Subject: TRIM: RMA/2022/3611 - Response to Council's visual effects peer review
Attachments: 2023-06-20 Braeburn - Letter to Tim Walsh - Landscape peer review.pdf; 2022_138 Braeburn Properties Portlink Industrial Subdivision_Landscape RFI Response_C.pdf; 2021_138 Braeburn Properties - Portlink Industrial Subdivision_RFI_C.pdf

BRAEBURN PROPERTY LIMITED: APPLICATION IN RELATION TO 320 & 320A CUNMOR TERRACE

**PORTLINK INDUSTRIAL SUBDIVISION – LANDSCAPE AND VISUAL
RFI RESPONSE_B**

The following memo is in response to the Landscape Peer Review and Visual Assessment of the proposed subdivision at 320 and 320A Cumnor Terrace, Christchurch prepared by Mr Jeremy Head, a consultant Landscape Architect on behalf of the Council, dated 17 May 2023.

Client / project name: BRAEBURN PROPERTIES- PORTLINK SUBDIVISION
 Drawing name: **VIEW 1 FROM FERRY ROAD**
 Designed by: CG
 Drawn by: CG/ NK
 Original issue date: 23 MARCH 2023
 Scale:

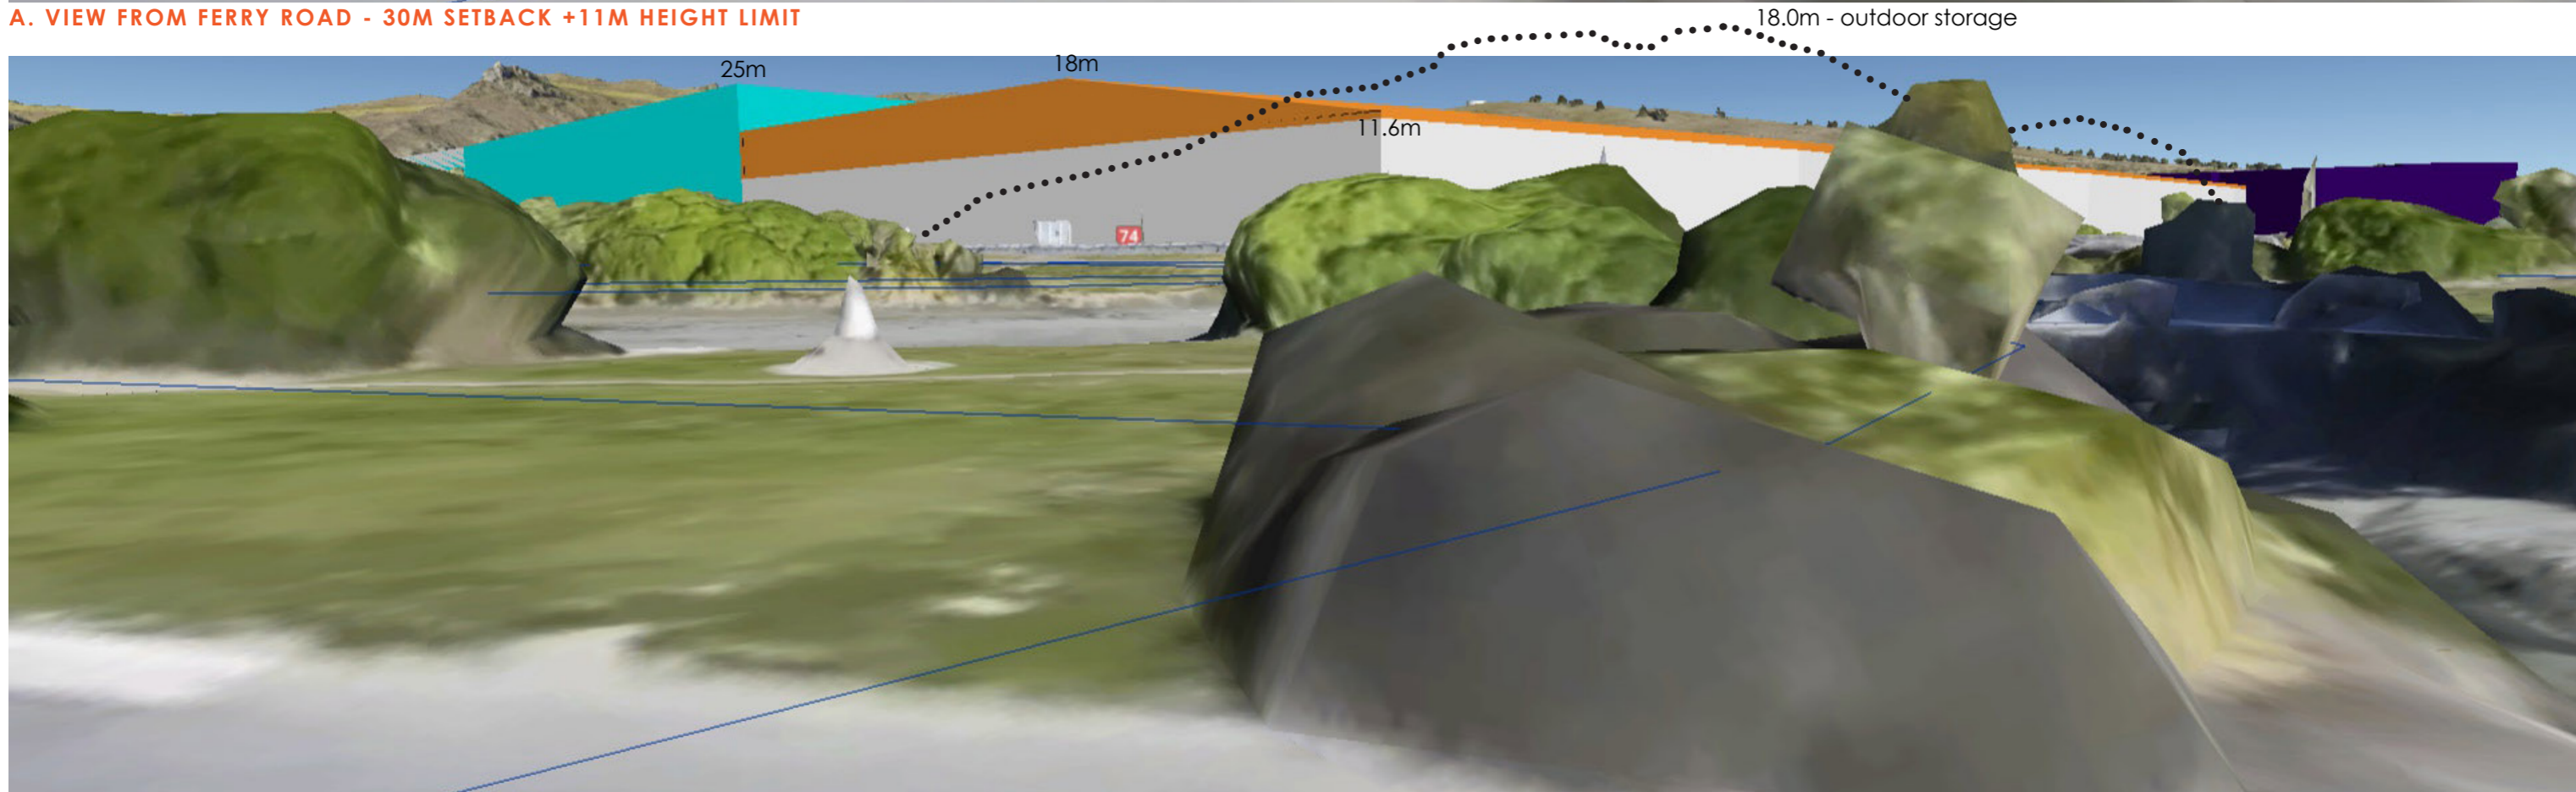
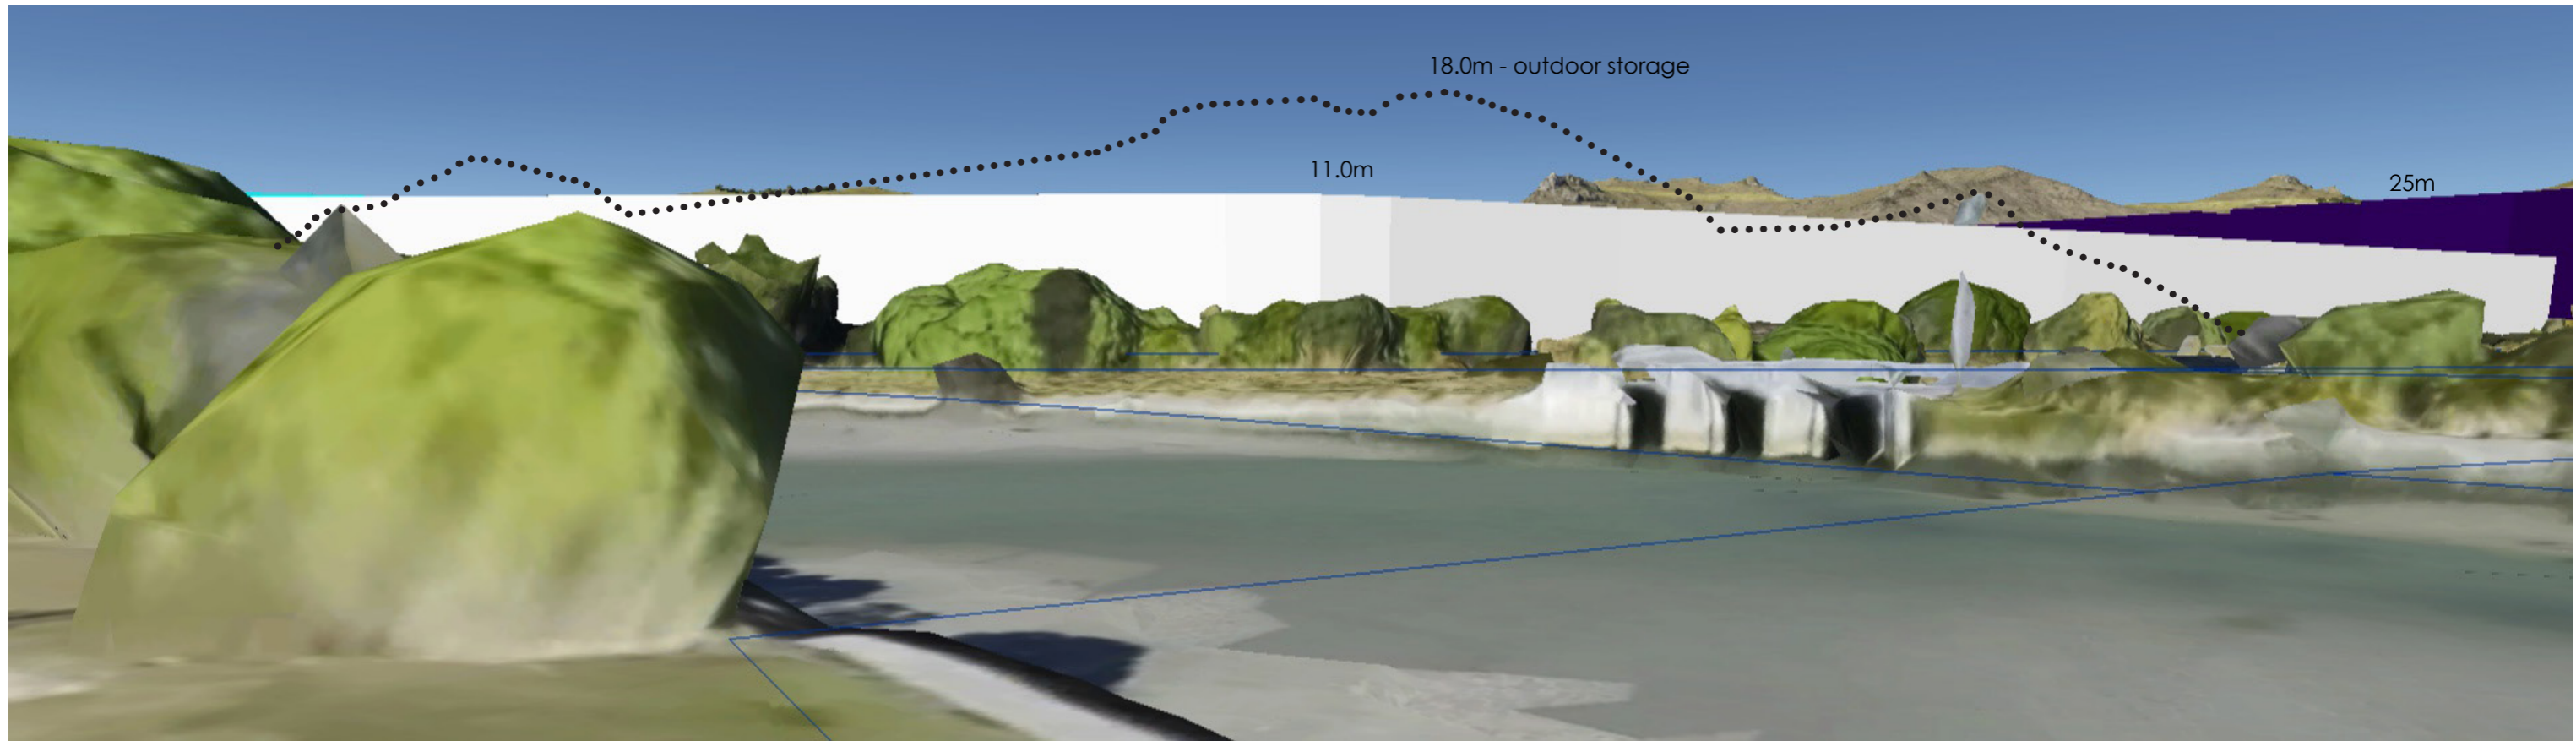
A. VIEW FROM FERRY ROAD - 30M SETBACK +11M HEIGHT LIMIT

B. VIEW FROM FERRY ROAD - PROPOSED +11.6M HEIGHT LIMIT

Viewpoint	Peer Review Assessment	Peer Review Assessment – mitigated	Distance	Comment	My assessment
1	853-909 Ferry Road (attachment 3, upper image)	Moderate-High	Moderate	130m	For shorter views it will be difficult to discern the difference between 11.0m and 11.6m. Only a relatively small portion of the outdoor storage/buildings will be visible above existing vegetation, and views of Montgomery Spur would also be blocked by permitted outdoor storage.	Very Low
2	32-38, 44, 44A, 52, 54 Gould Cres (attachment 5, lower image)	Moderate	Low-Moderate	80m	There will be a loss of views of the Port Hills with the existing permitted baseline from this viewpoint as outlined in Section 3 above. When looking at the greater 600mm height proposed and the closer proximity to the river, taken from the new ground level, the change will be discernible from this location but when compared to the view with the established permitted baseline any effects are considered low.	Low

Client / project name: BRAEBURN PROPERTIES- PORTLINK SUBDIVISION
 Drawing name: **VIEW 2 FROM NEAR 32 GOULD CRES**
 Designed by: CG
 Drawn by: CG/ NK
 Original issue date: 23 MARCH 2023
 Scale:

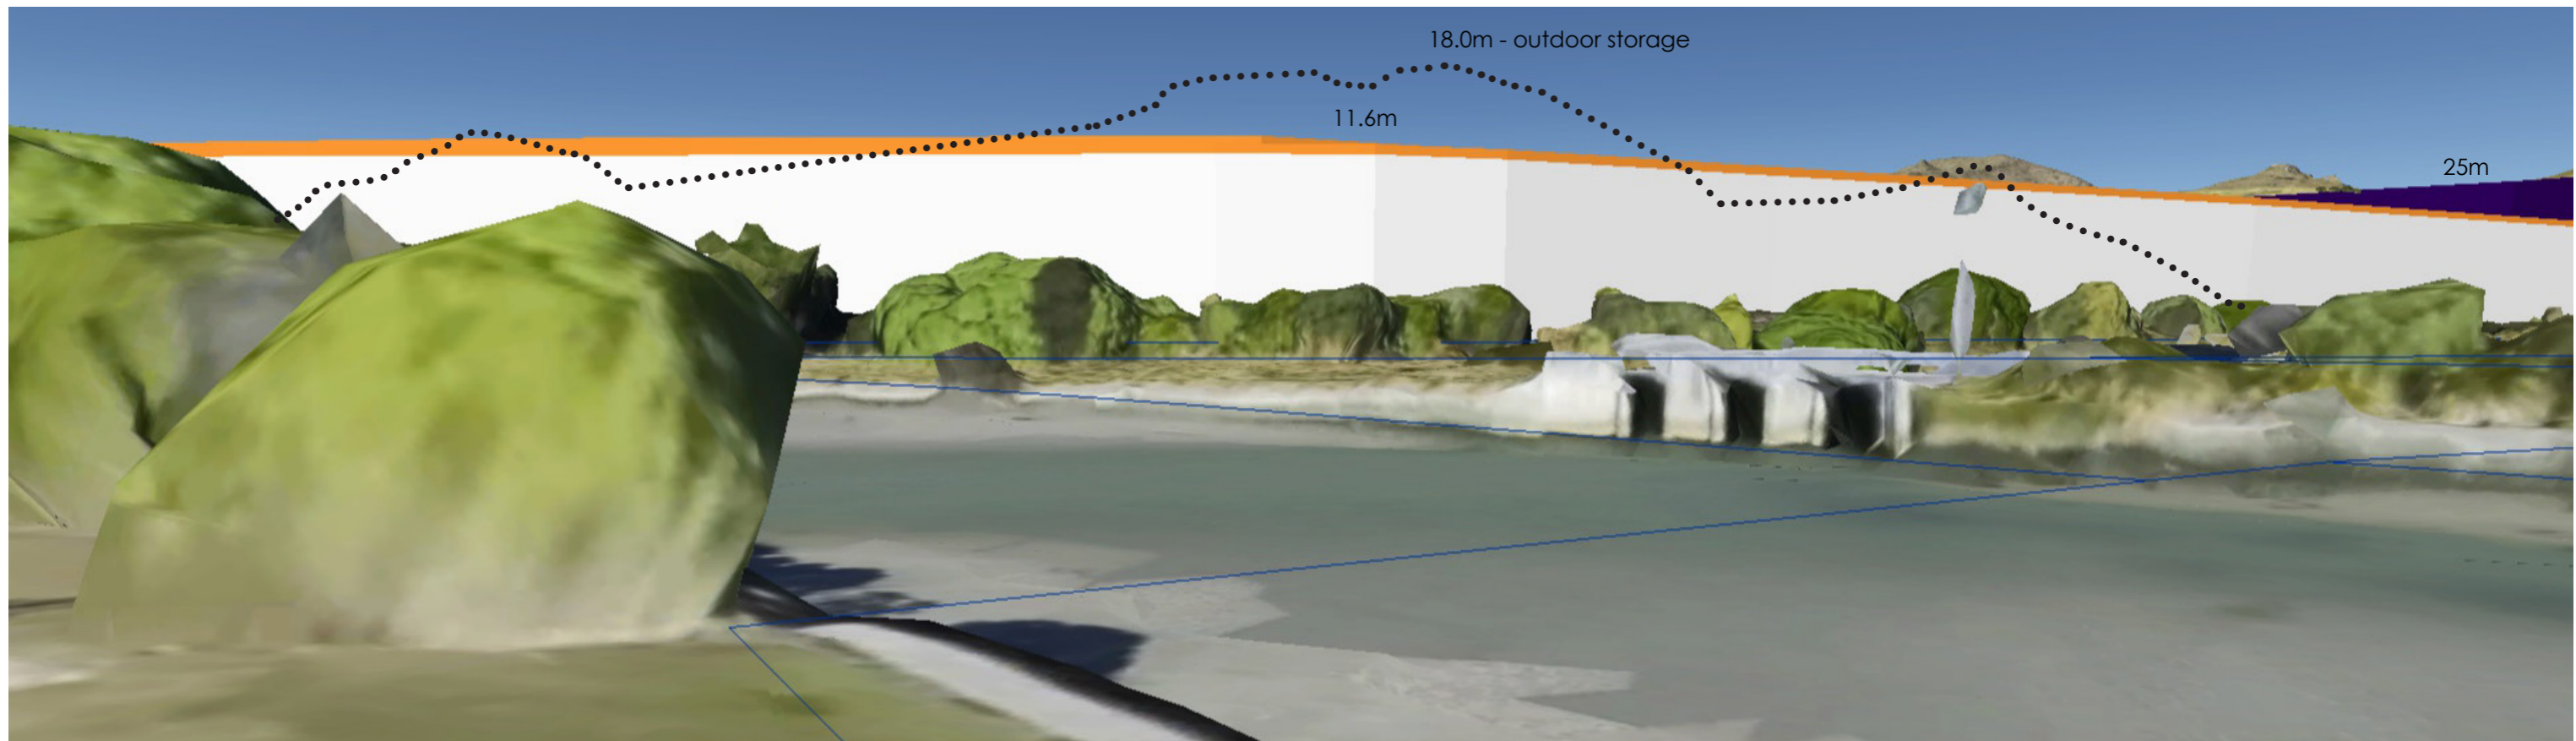
A. VIEW FROM NEAR 32 GOULD CRES - 30M SETBACK +11M HEIGHT LIMIT

B. VIEW FROM NEAR 32 GOULD CRES - PROPOSED +11.6M HEIGHT LIMIT

3	Remainder of Gould Cres (attachment 5, upper image)	Moderate - Low	Low	120m	As mentioned in the peer review report, partial views of the Port Hills will be possible of both the 11.0m high scenario and the 11.6m scenario and closer proximity. The intervening distance means that the difference between 11 and 11.6m will be difficult to discern.	Very Low
4	Long and Barton Streets (attachment 9, Attachment 10 upper image)	Moderate	Low	80-90m	At this distance the additional height and closer proximity will be discernible but it will not increase any loss of views towards the Port Hills or create any visual dominance issues. The resultant change is therefore considered to be Low.	Low
5	Travellers in the receiving environment (Attachments 2-10)	Low	Very Low	Varies	Agree with Mr Head's findings although I consider the effects to be Very Low from Day 1 due to the transient nature of views of the Proposal at high speed.	Very Low

- **Figure 4 - Concrete piles at 59 Owaka Road, Hornby (Industrial Park Zone)**

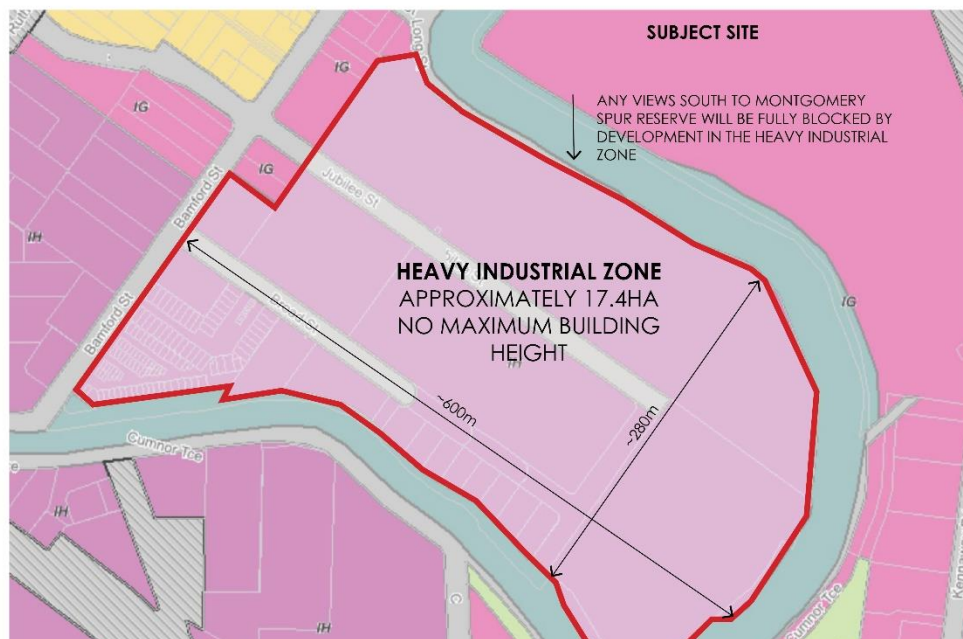
Outdoor storage yards are a permitted activity in the Industrial zone with no maximum height restriction. The photo below shows a scrap metal yard in Bromley where material is estimated to be stacked to a height of 12-14m. There is the potential for any type of material to be stacked to a greater height than the proposed 11.6m or 18m height limits. Other materials could include crushed cars, crushed concrete or construction demolition material as shown in the images following.
